Docket No. 50-423
B11266

Millstone Nuclear Power Station, Unit No. 3
Submittal of
Revised Response to Effluent Treatment System Open Item

ETSB-1: ESF Atmosphere Cleanup System

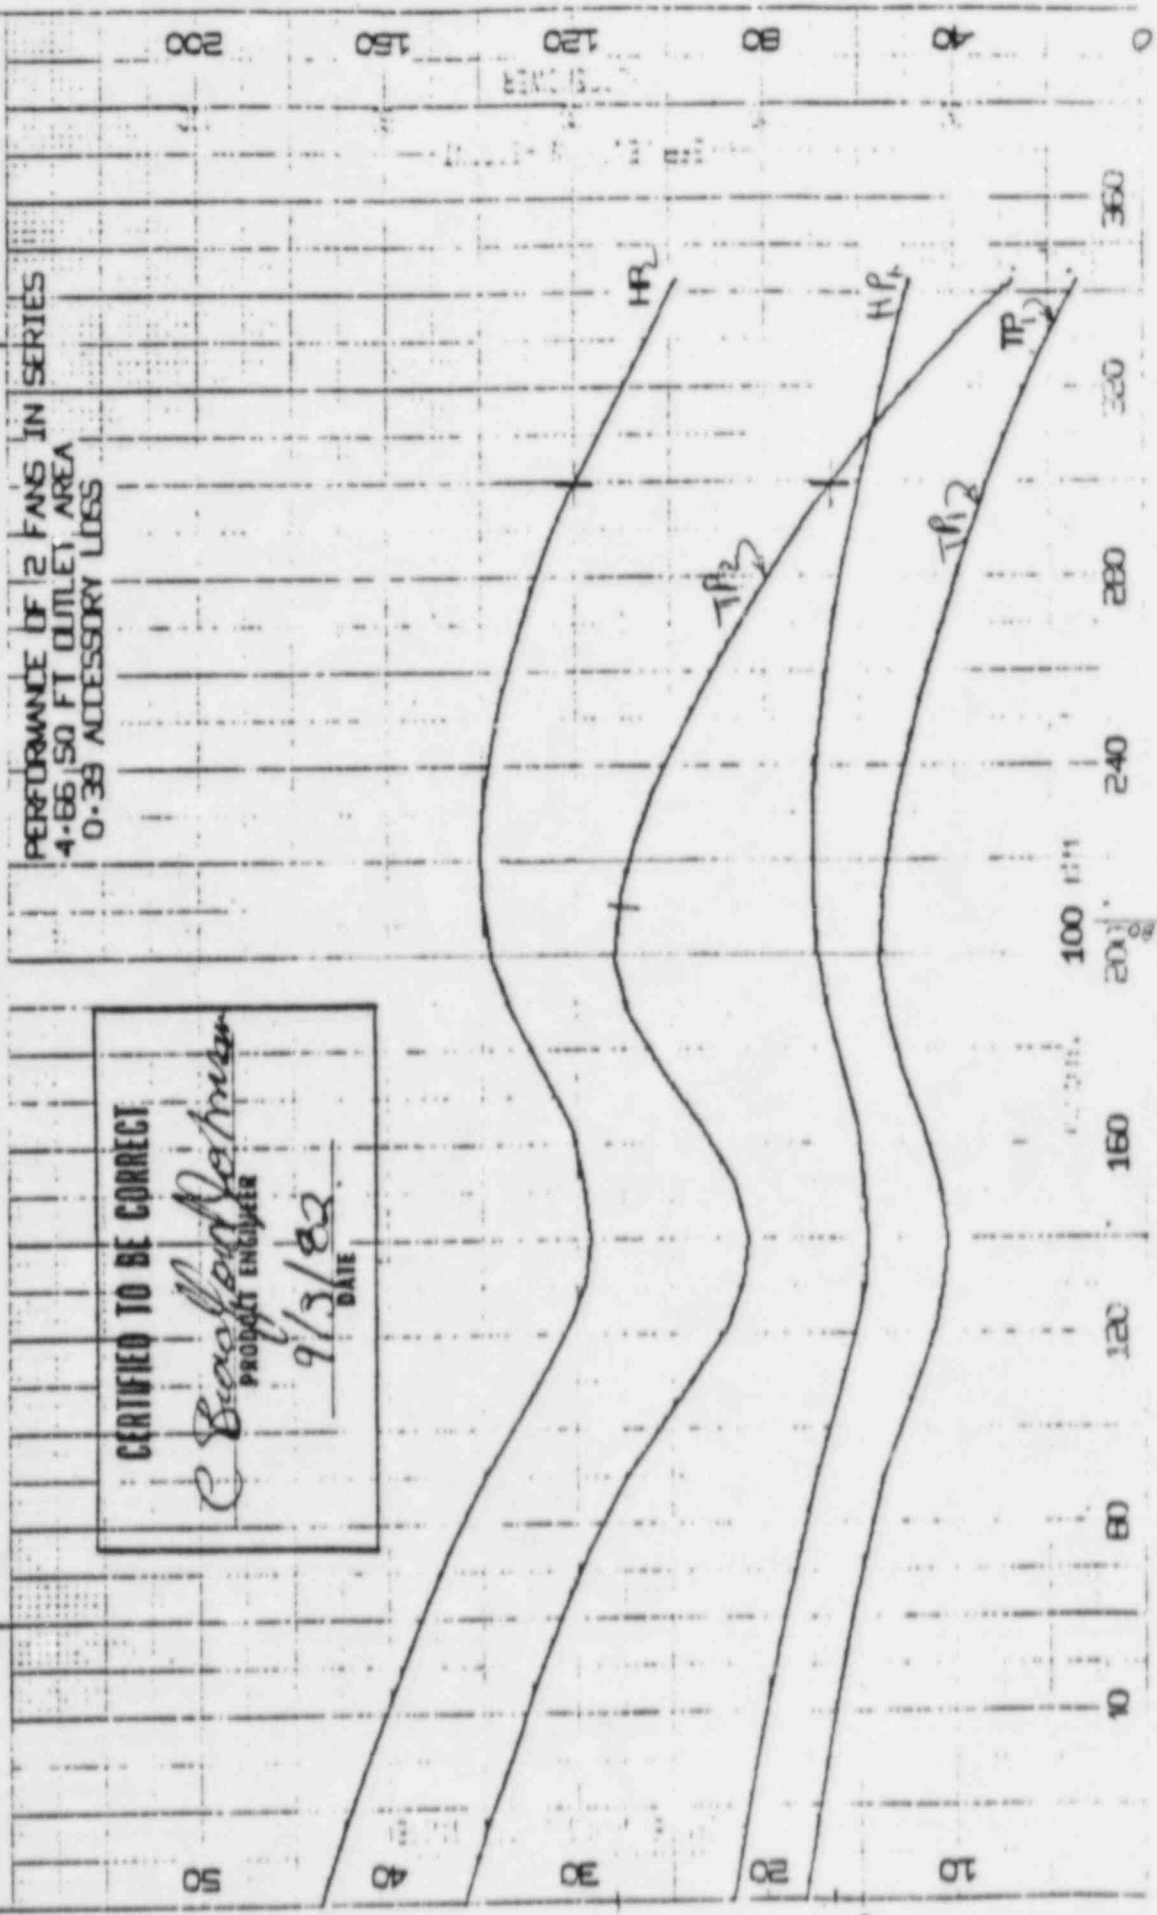
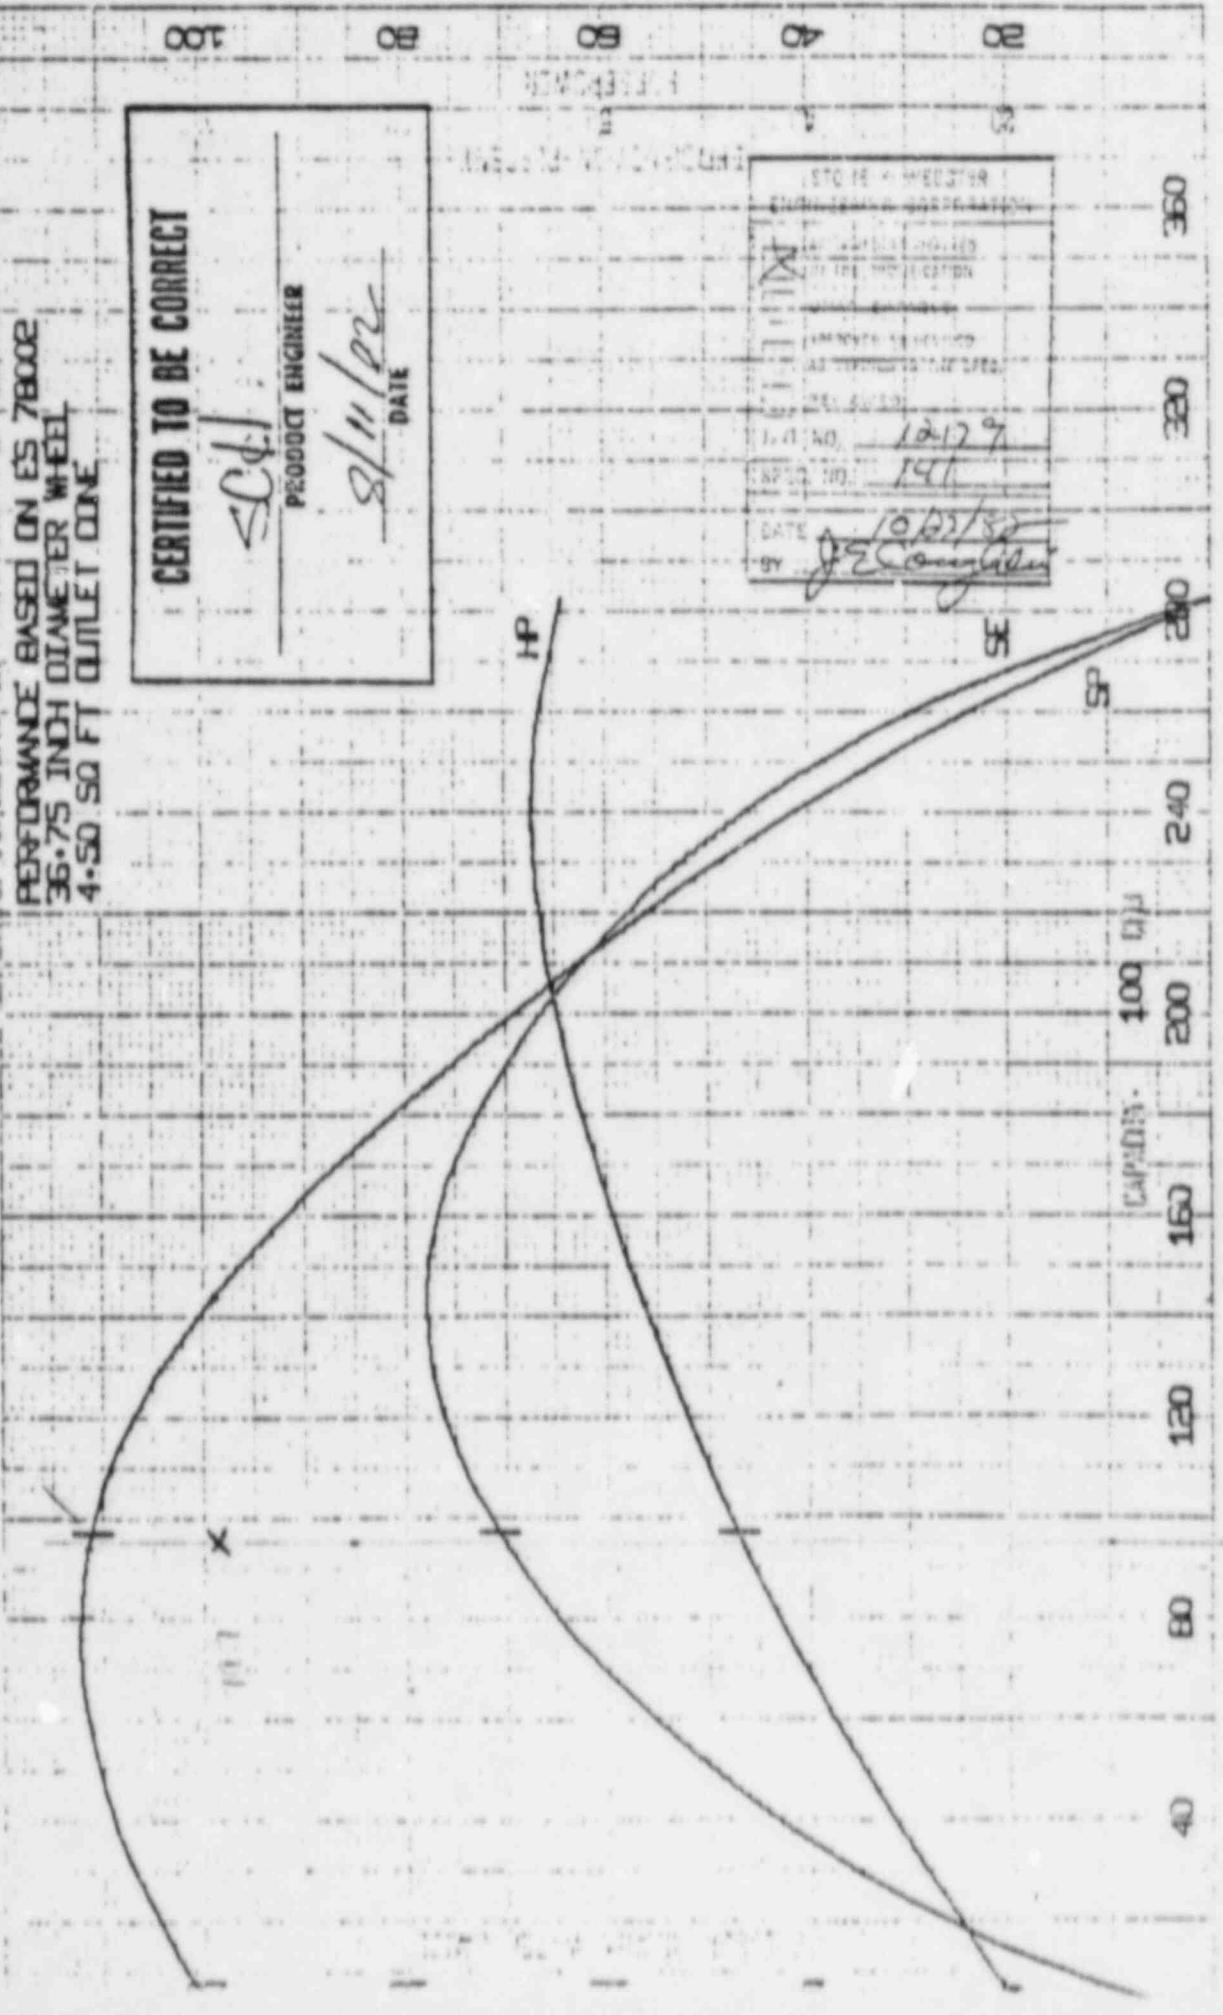
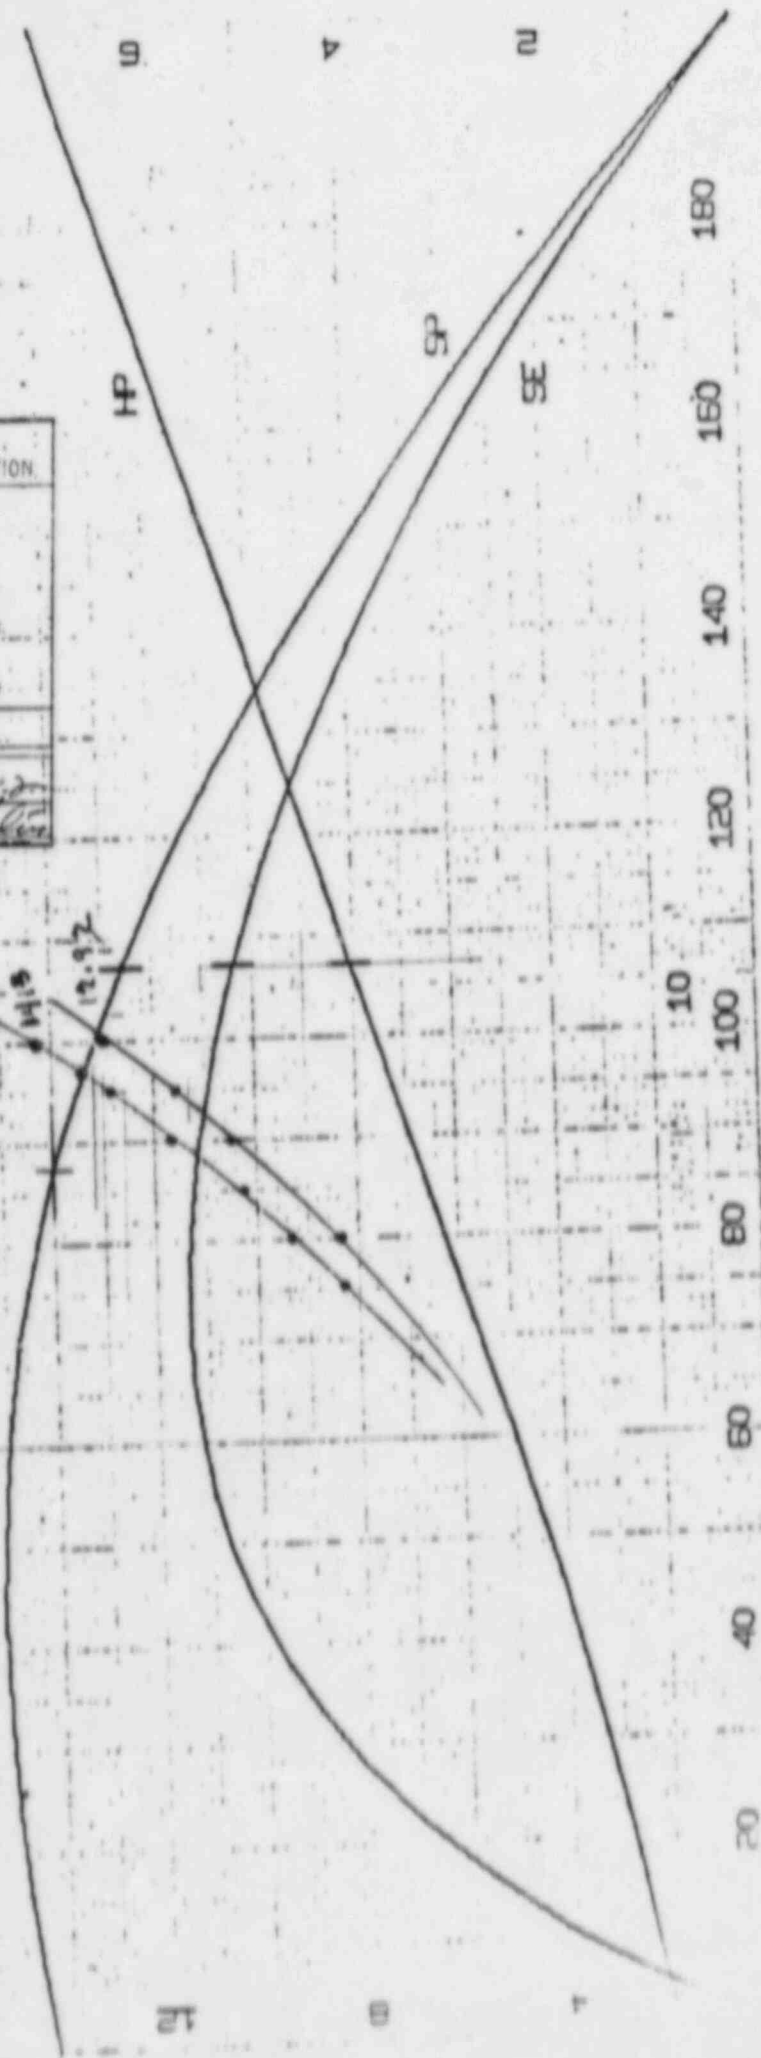
SRP Section 6.5.1, Revisions 1 and 2, and RG 1.52, Revisions 0, 1, and 2, call for each ESF atmosphere cleanup system to be instrumented to signal, alarm, and record pressure drop and flow rate at the control room. Millstone Unit 3 ESF atmosphere cleanup systems are provided with only local pressure differential indicators across each filter with a common alarm in the control room for high pressure differential across the filter bank. The pressure differentials across each filter are transmitted to the plant computer in the main control room. The applicant stated in the FSAR that periodic surveillance tests will be performed to ensure design flow rates through each ESF atmosphere cleanup system. The staff will complete its evaluation after further discussion with the applicant regarding indicators and recorders in the main control room. This issue will be addressed in the final SER. This is an open item.

3. In-place testing will establish the design flow with system resistance corresponding to design dirty filter condition. The dp alarm setpoints for each ESF filter train system can be set to correspond to the (-10%) flow condition through the respective filter train system to ensure that during all operating conditions flow is maintained within $\pm 10\%$ of design flow.

The ESF systems fans are fixed speed fans, and the system flow rates vs. pressure drops will be verified during plant operation utilizing the attached fan curves.
